COLORADO DEPARTMENT OF TRANSPORTATION REEVALUATION FORM	Original NEPA Approval Date: 1/19/2017	Reevaluation Date: 11/15/2018	Project Code: AQC R600- 165 Subaccount: 13599
Project Name and Location: Central 70 Project: Reevaluation #5, I-70 from I-25 to Chambers Road			
NEPA Document Title: I-70 East ROD 1: Phase 1 (Central 70 Project) (January 19, 2017)			
Region/Program/Residency: Headquarters—Central 70 Project Office			
<p>Project Description:</p> <p>The Preferred Alternative, Phase 1 (Partial Cover Lowered Alternative with Managed Lanes) selected in the January 19, 2017 Record of Decision (ROD) is the first phase of implementing the Preferred Alternative identified in the Final Environmental Impact Statement (FEIS). The Preferred Alternative, Phase 1 removes the existing Interstate 70 (I-70) viaduct between Brighton Boulevard and Colorado Boulevard and lowers the highway below grade in this area, placing a four-acre cover over a portion of the lowered highway (between the Clayton Street and Columbine Street bridges, adjacent to Swansea Elementary School), and adds additional lanes in each direction.</p> <p>Reevaluation #1 dated 9/18/2017 assessed the impacts of three categories

Figure 3: Best Inn & Suites (4595 Quebec St) and Denver Rock Island (4600 Niagara) Impacts

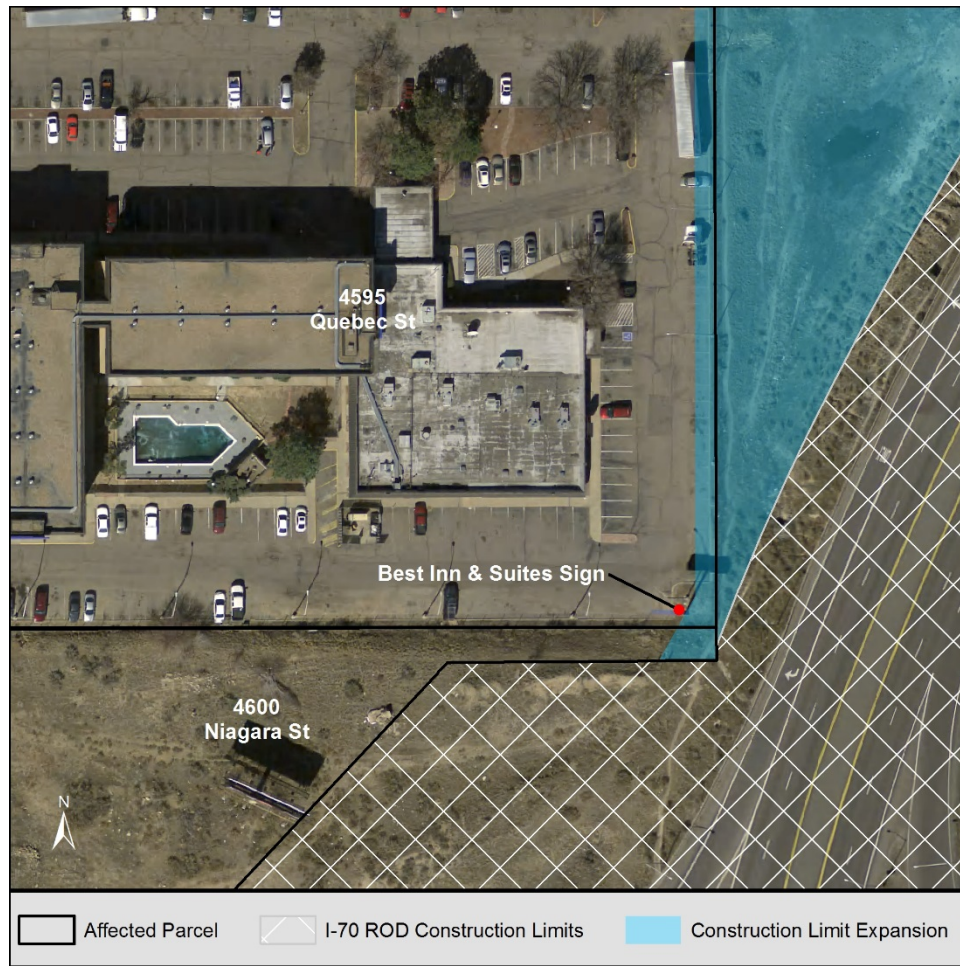
Design Alteration #1 requires approximately 0.1 acre of construction limit expansion onto the Best Inn & Suites property to tie in fill slopes to existing grades and tie in or extend drainage structures. As a result of this expansion, construction may conflict with the Best Inn & Suites sign (see **Figure 3** in the Land Use and Zoning discussion), and relocation or replacement of the sign may be required. Replacement or relocation of the sign will be dependent on right of way appraisal. Consistent with ROD Mitigation Commitment #5, the property owner will be compensated according to the U.S. Constitution and the Uniform Act of 1970, as amended.

As shown in **Table 2**, advanced design has resulted in an increase in ROW and permanent easement acquisition of approximately 0.1 acres from one parcel—4595 Quebec Street. This increase in ROW and easement acquisition results in a small conversion of existing commercial use into a transportation use. The acquisition on 4595 Quebec Street (Best Inn & Suites) is required to accommodate sidewalk and adjacent wall construction and maintenance limits based on refined Quebec Street Roadway geometry, as well as new inlets, manholes, and extension of existing storm drain pipes. The overall function of the property would remain unchanged. In addition, the ROD had previously proposed approximately 0.3 acre of ROW acquisition on a portion of Denver Rock Island property (4600 Niagara Street). Design Alteration #1 would increase ROW and easement acquisition on the Denver Rock Island property by approximately 0.01 acre on a vacant portion of the property. None of these changes affect zoning within the area, and the project would remain consistent with local and regional plans. **Figure 3**, below, reflects the changes at Best Inn & Suites and Denver Rock Island property. Expansion of the construction limits on 8801 E 39th Avenue, as shown in **Attachment A**, would occur within an existing CDOT drainage easement; therefore, no additional acquisition is proposed and existing uses would be maintained.

Figure 5: Sanitary Sewer Alignment within OU2 and Solid Waste Landfill

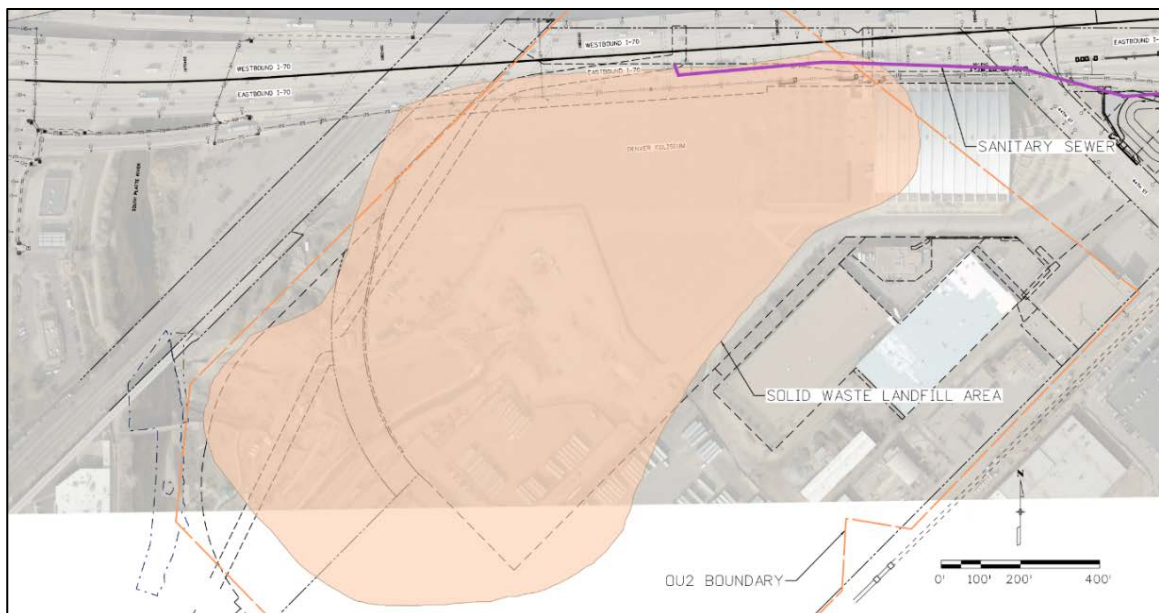
- The ATC 11.2 sanitary sewer alignment remains within ROD construction limits, is north of the Coliseum, and its location will require coordination with the City and County of Denver (CCD). See **Figure 5**.

With regard to Design Alteration #3, the sanitary sewer realignment crosses into Operable Unit 2 (OU2) of the Vasquez and I-70 National Priority List (NPL) site (see **Figure 4 and Figure 5**), creating approximately 500 linear feet of excavation approximately 15 feet deep in OU2. OU2 addresses soils and groundwater contamination within approximately 50 acres of the original Omaha and Grant Smelter. The alignment also crosses into a Solid Waste Landfill within OU2 (see **Figure 5**). By raising the profile of I-70, impacts with excessive excavation and contaminated groundwater are avoided in the lowered section of I-70. The raising of I-70 also eliminates the need to treat the contaminated groundwater during the operations and maintenance phase of the project. The reduced excavation in potentially contaminated soils and groundwater treatment throughout the life of the lowered section more than offsets the impacts of the sanitary sewer line through the OU2 area and the Solid Waste Landfill within the OU2 boundary. The landfill include embankment fills, artificial fill and domestic refuse, with no hazardous or industrial waste reported. Overall, there has been a net reduction in impacts to solid waste landfill sites--from the seven identified as impacted within the study area in the ROD and previous revaluations, to six with the elimination of the north offsite outfall (as disclosed in Reevaluation #4).
